Feedback for Little Falls Parkway Improvements

National Capital Planning Commission
ATTN: Michael Weil, Little Falls Parkway Environmental Assessment

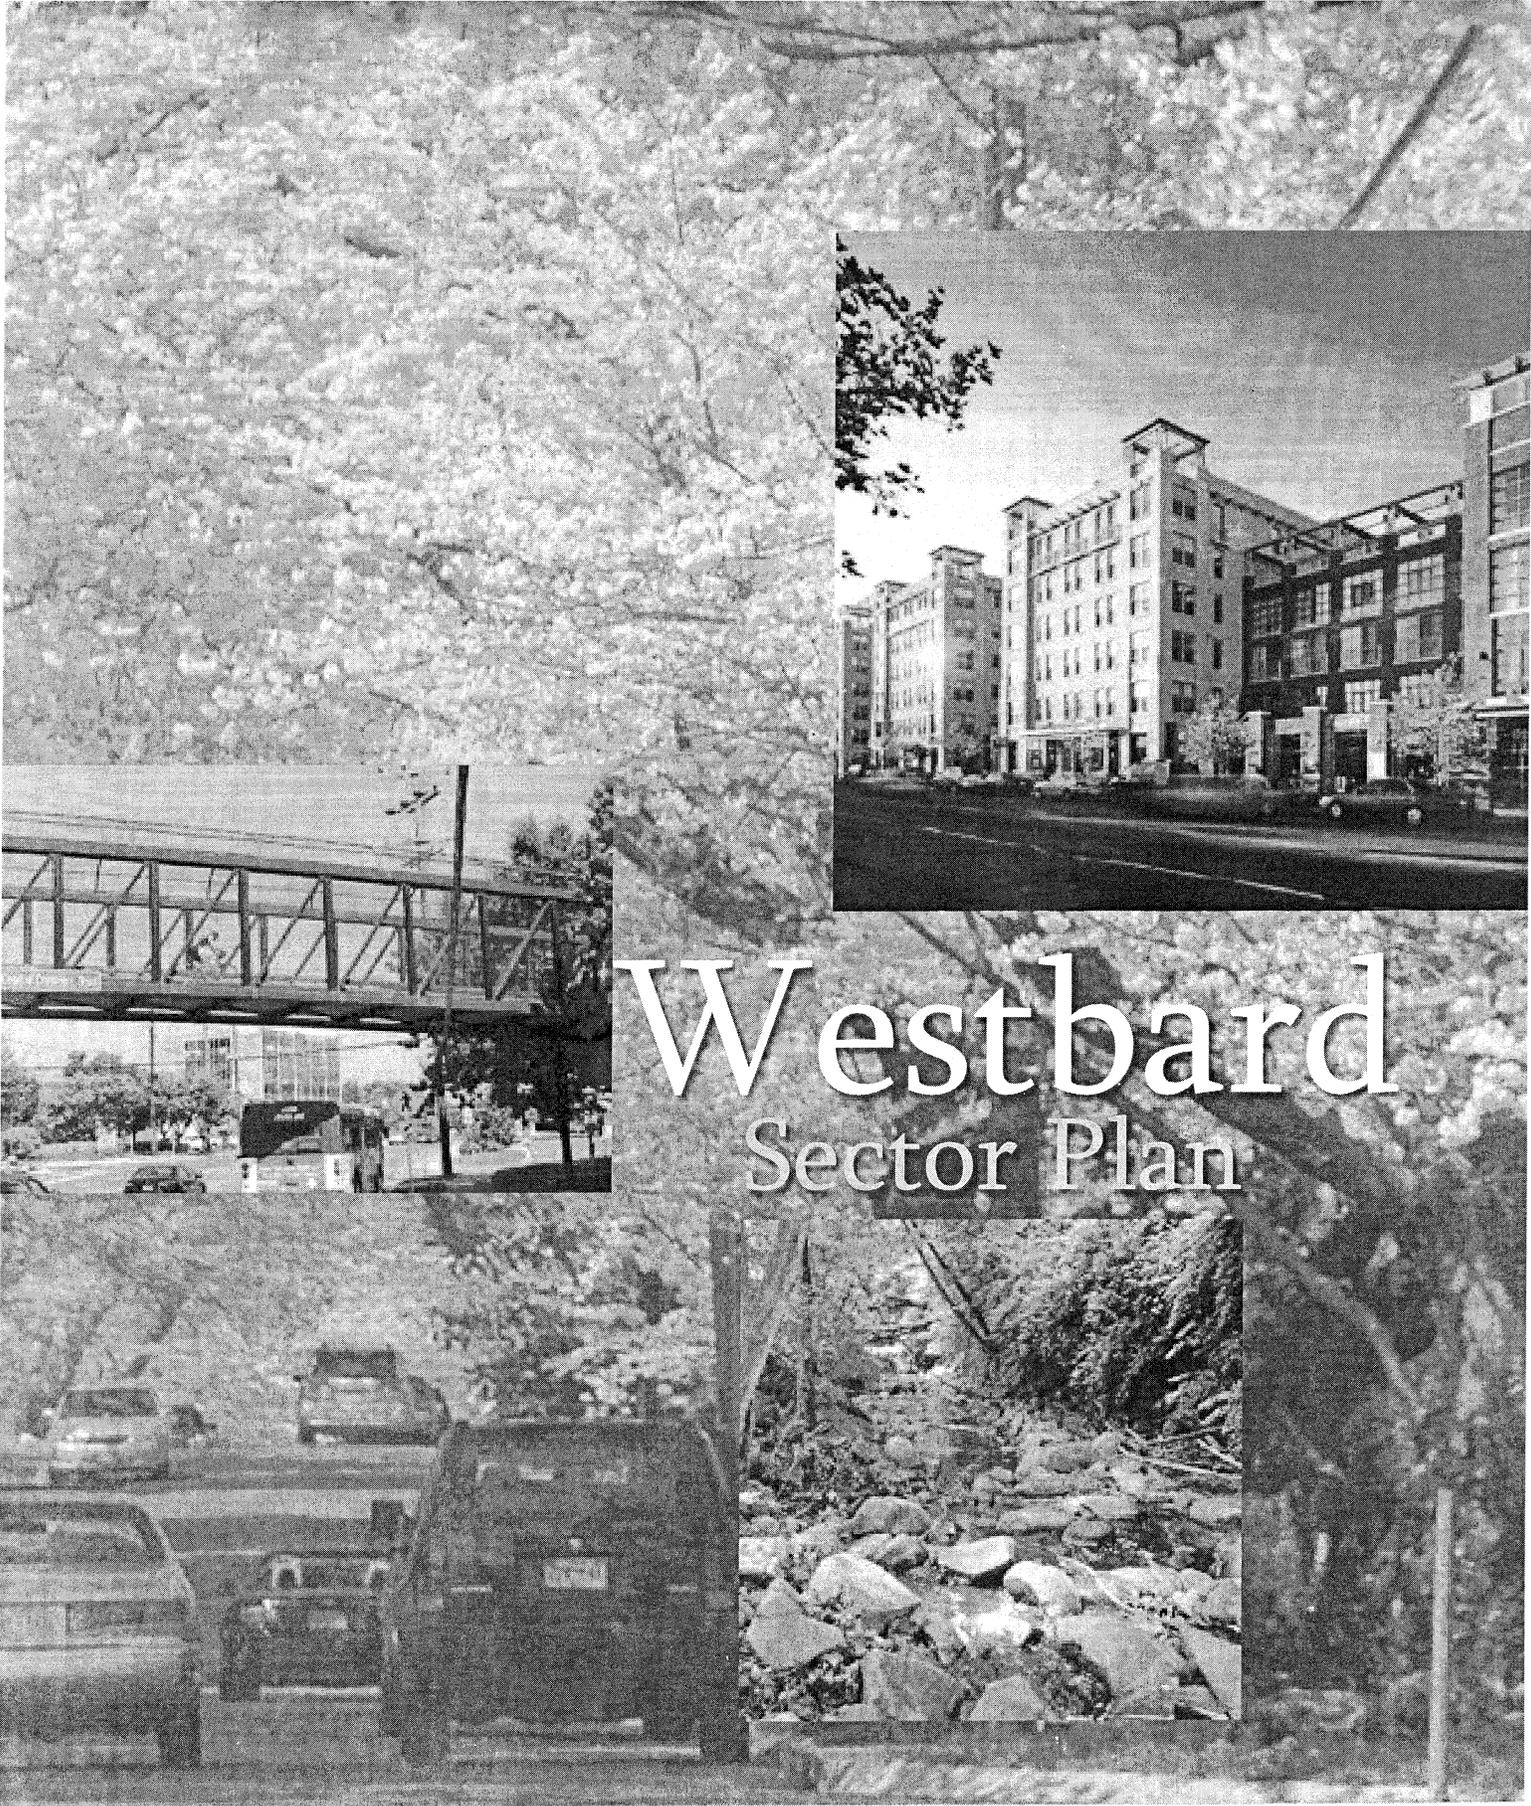
The draft EA also refers to “traffic calming measures” [plural] (p. 39) but does not appear to identify and document them except elsewhere as to the reduction of the number of road way lanes from four to two.

The draft EA says the “Pilot Program has resulted in substantial crash reductions along the parkway and at the CCT crossing. Since the raised crosswalk was installed in 2020, no crashes have been reported at the CCT crossing, as compared to six crashes in 2016 alone.” p. 39. But 2016 was before the road diet on the LFP and there were no crashes in 2020 and 2021, which were before the Phase I reconfiguration. Cause and effect are not what Parks seemingly makes them out to be.

The draft EA says, “as shown in the table above (Figure 8), the number of CCT crashes has decreased from six to zero (which represents a 100% decrease), and this trend would be expected to continue under the build condition.” But figure 8 is a photo and once the number has decreased to zero, a downward trend cannot be continued.
